PROJECT #: Project #3317-01  
RE: Comprehensive Permit  
Technical Review Response  
444 East Central Street  
Franklin, MA

On behalf of our client, TAG Central LLC, and in coordination with Beals Associates, Allen & Major Associates, Inc. (A&M) is providing the following responses to outstanding items noted in the letter dated November 10, 2025, from Hancock & Associates regarding the Comprehensive Permit. A&M's responses to final comments are shown below in **bold**.

PROJECT:  
**40B MULTIFAMILY**  
444 EAST CENTRAL STREET  
FRANKLIN, MA

DRAWING TITLE: **EROSION CONTROL & SITE PREP PLAN** SHEET No. **C-101A**

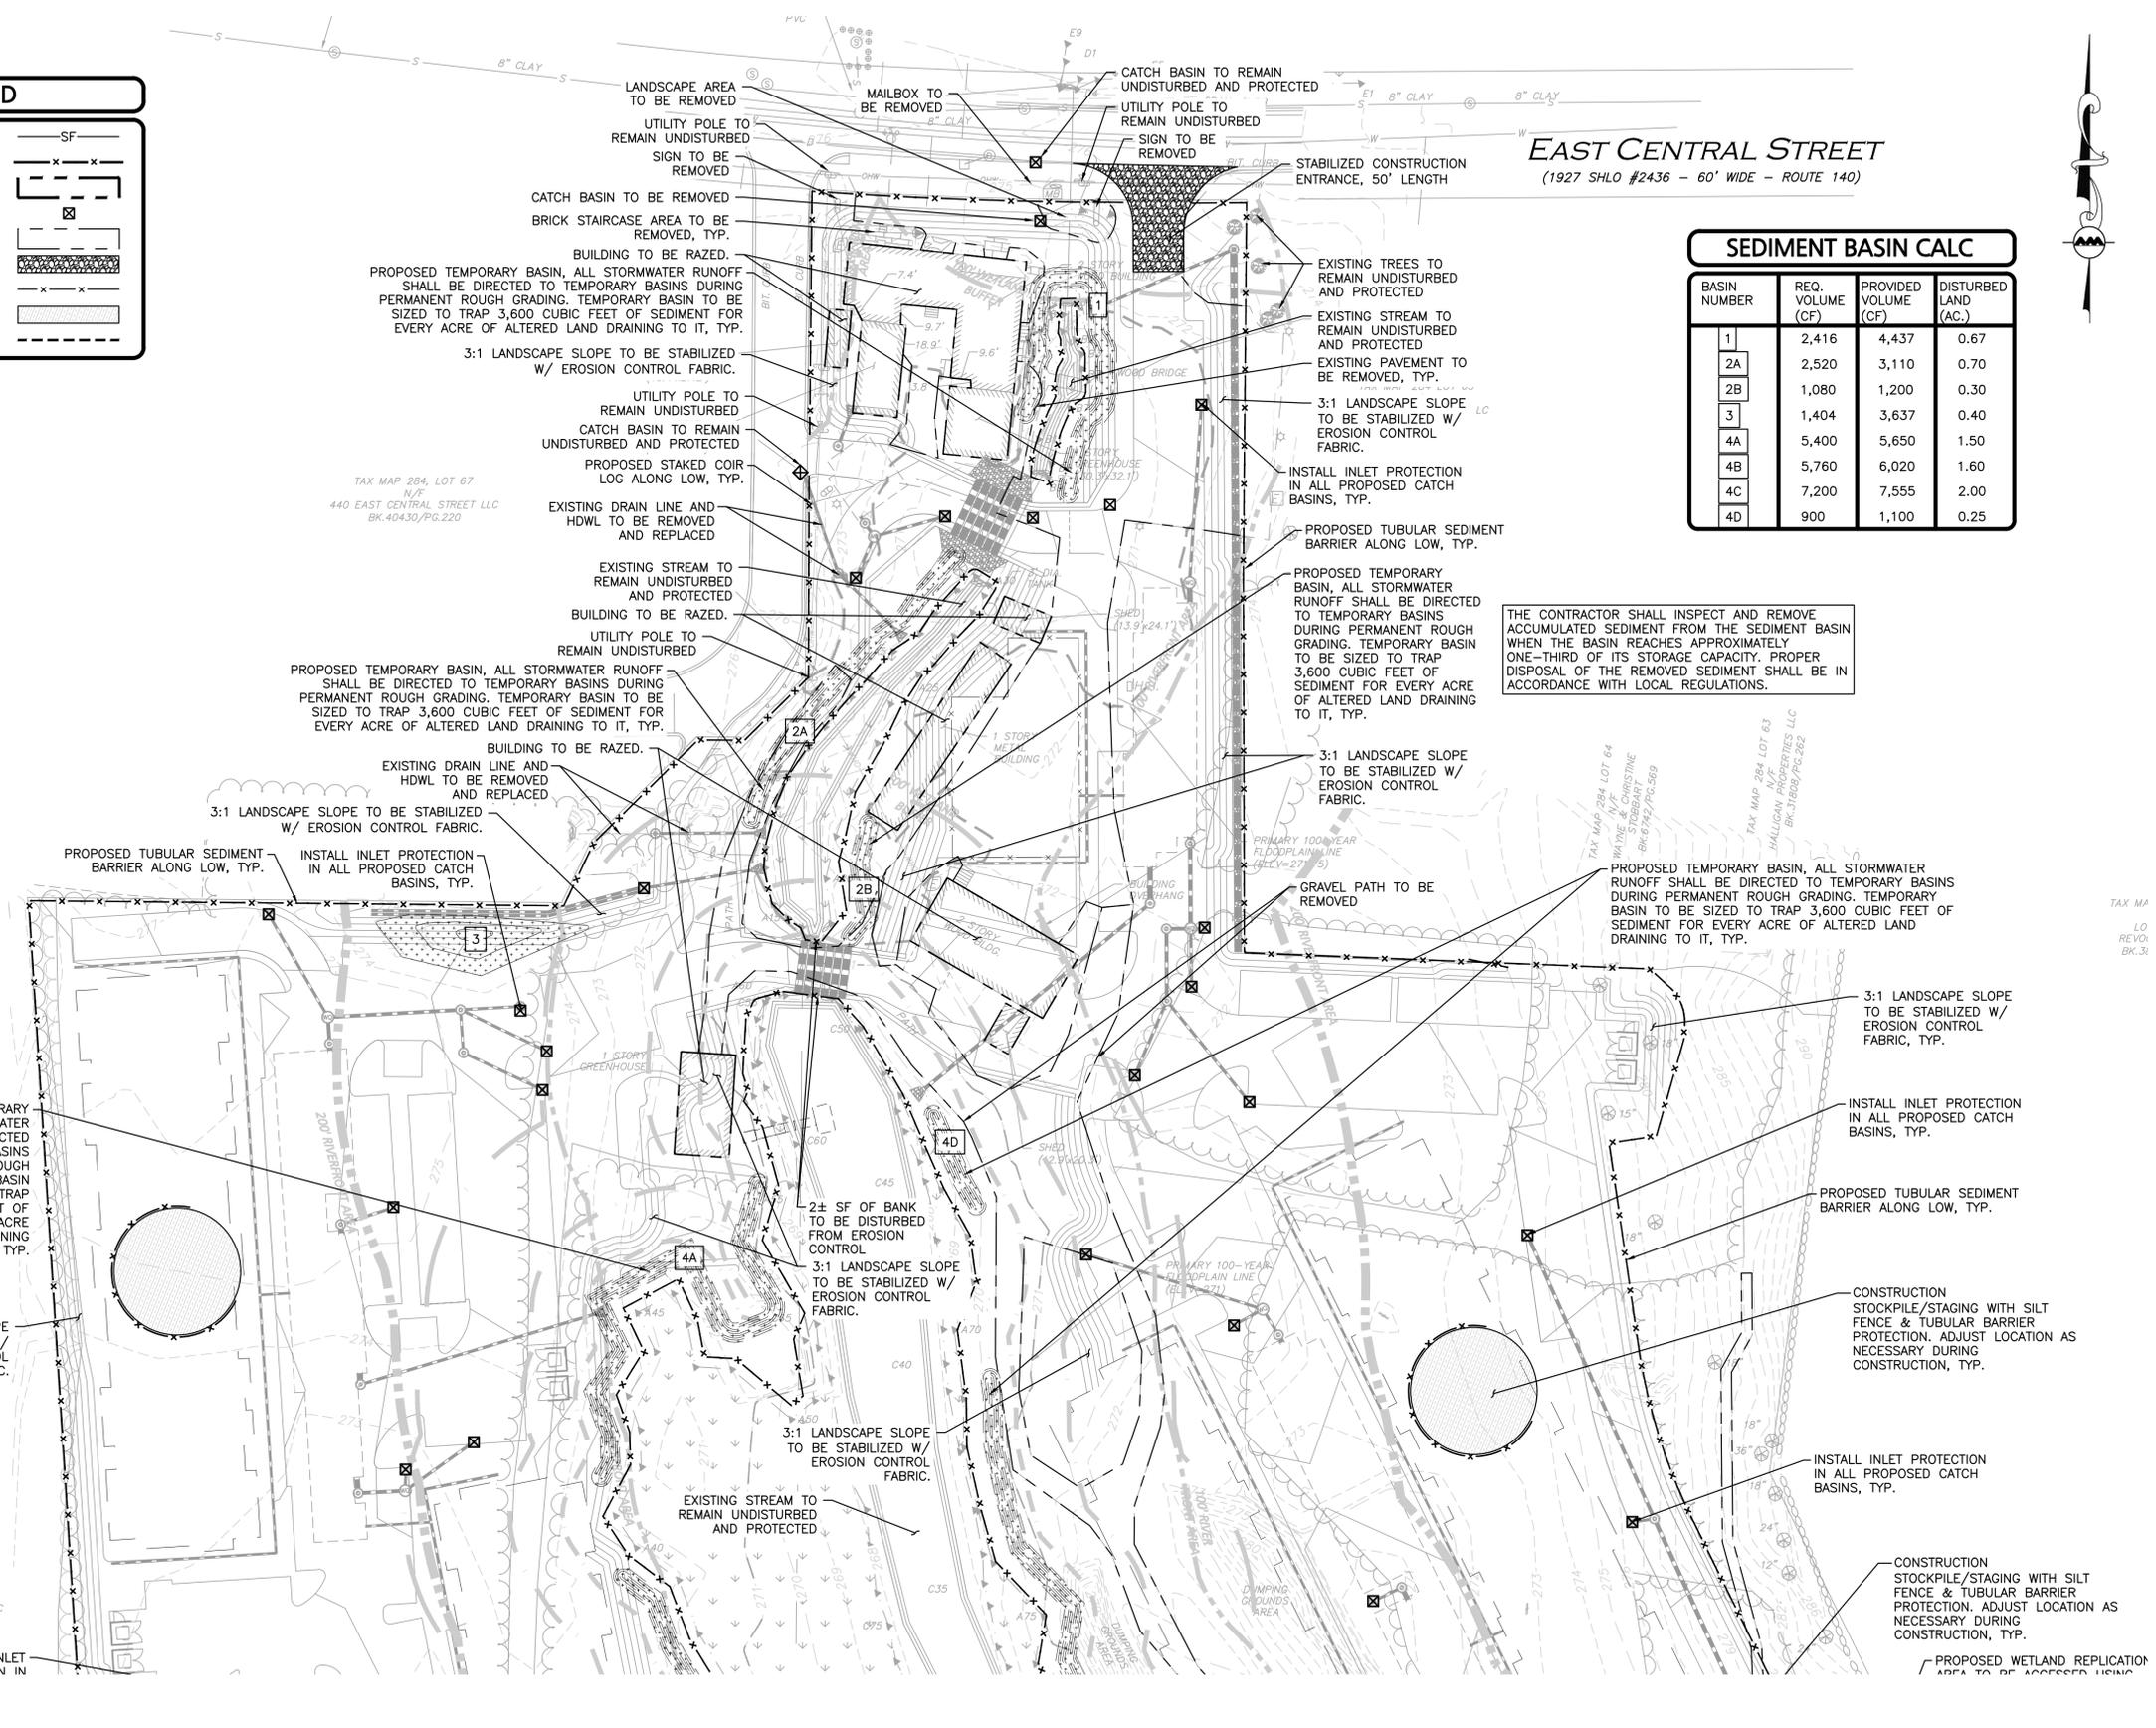
*Hancock Response: The revised plans provide sizing for the proposed temporary sediment basins. While Hancock agrees with the methodology of providing ample volume. Four distinct basins are shown on the plan, all being labeled TSB #4. These should be broken into four with the required volumes of each provided based on the contributing area to each.*

**A&M Response: The attached plan has been updated to illustrate the TSBs broken into four, with required volumes of each provided based on the contributing area to each.**

DRAWING TITLE: **PROPOSED WETLAND BUFFER DISTURBANCE 0-25' BUFFER**  
 SHEET No. **EXH-6**

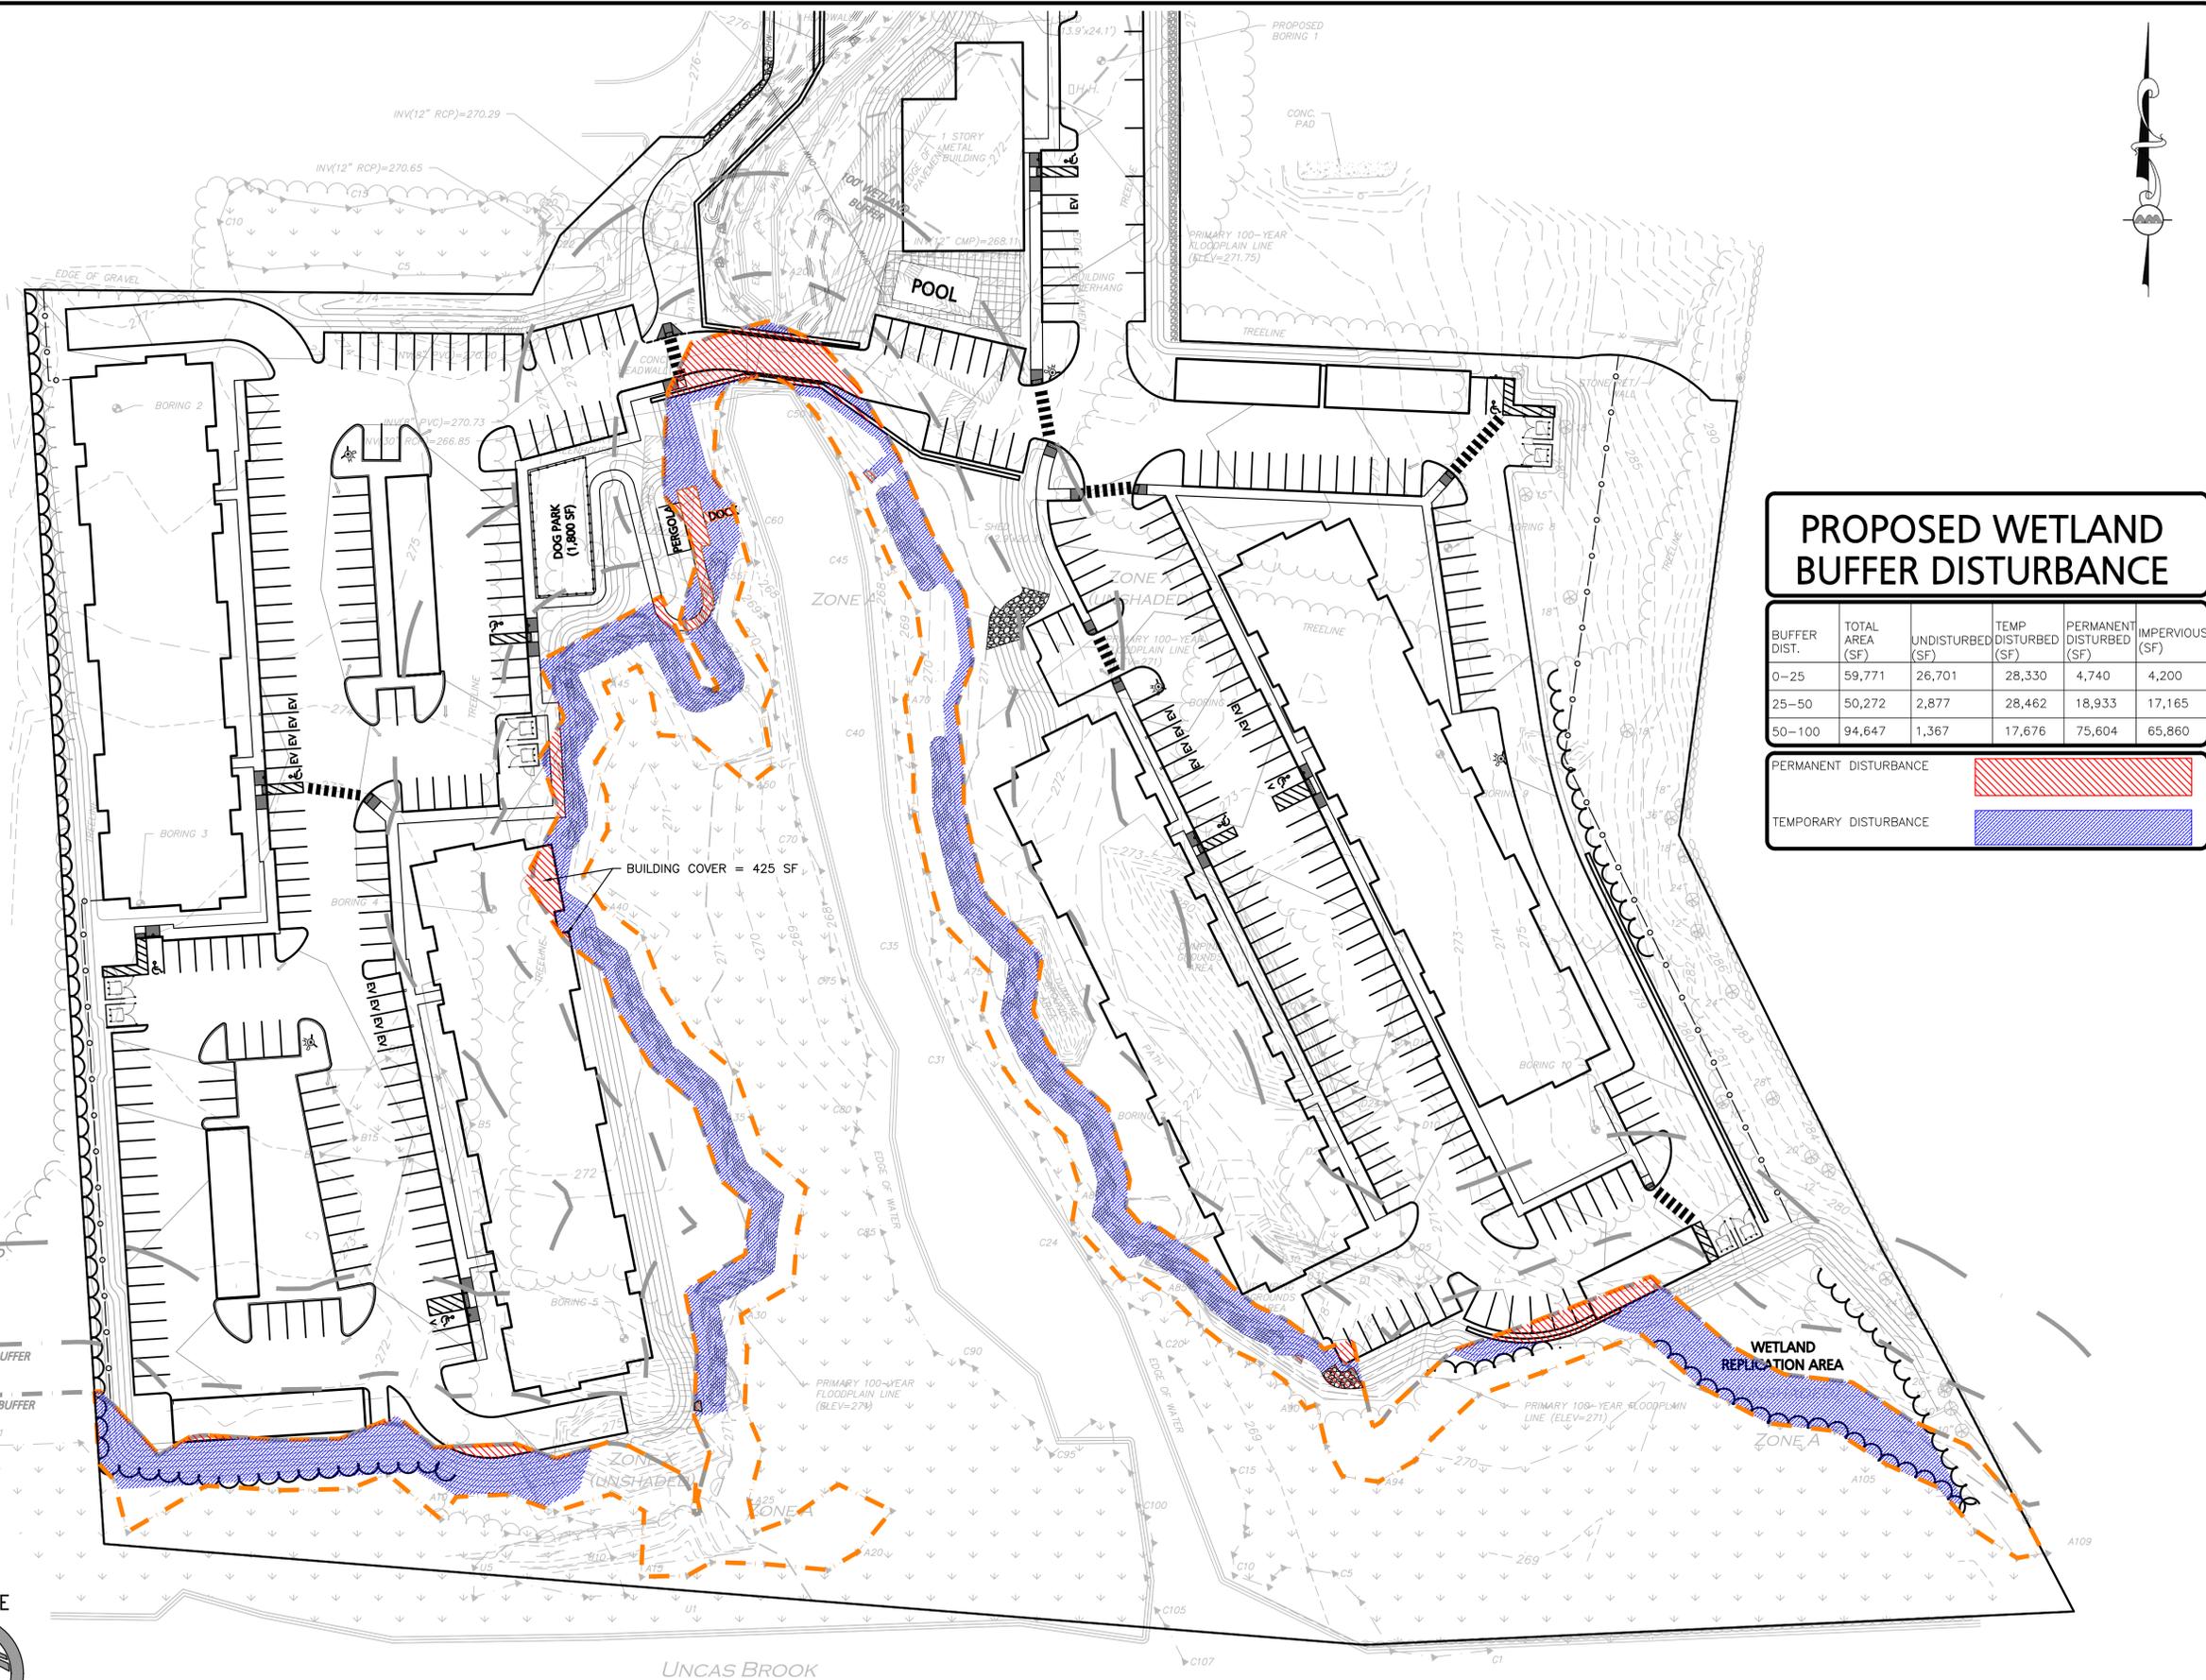
*The Applicant has submitted a revised List of Waivers dated October 29, 2025. At the last hearing on October 23, 2025, the Board requested clarification and to quantify the relief regarding the Wetland Franklin Wetlands Protection Regulations for the work within 25' of the wetland, structures within 50' of the wetland, the quantity of impervious within the buffer zone. Hancock suggests the Board require submission of alternatives analysis per Section 7.13 of the Wetlands Regulations to allow for proper deliberation of the other requested waivers.*

**A&M Response: As requested, please find attached a copy of the alternatives analysis per Section 7.13 of the Wetland Regulations to allow for proper deliberation of the other requested waivers; this was already submitted to and reviewed by the Conservation Commission and their peer-review consultant as a part of our Notice of Intent Application revised through 11/4/25. For brevity purposes, we extracted the alternatives analysis section only from the Notice of Intent Application and attached it to this letter. As for the Board's comment from the last hearing on 10/23/25, we've prepared an analysis entitled Proposed Wetland Buffer Disturbance analysis, which is attached hereto, that quantifies the work to take place within the 25' wetland buffers, 50' buffers, and quantity of impervious within the buffer zone. Given that the requested information has now been submitted, the Applicant considers this item closed.**
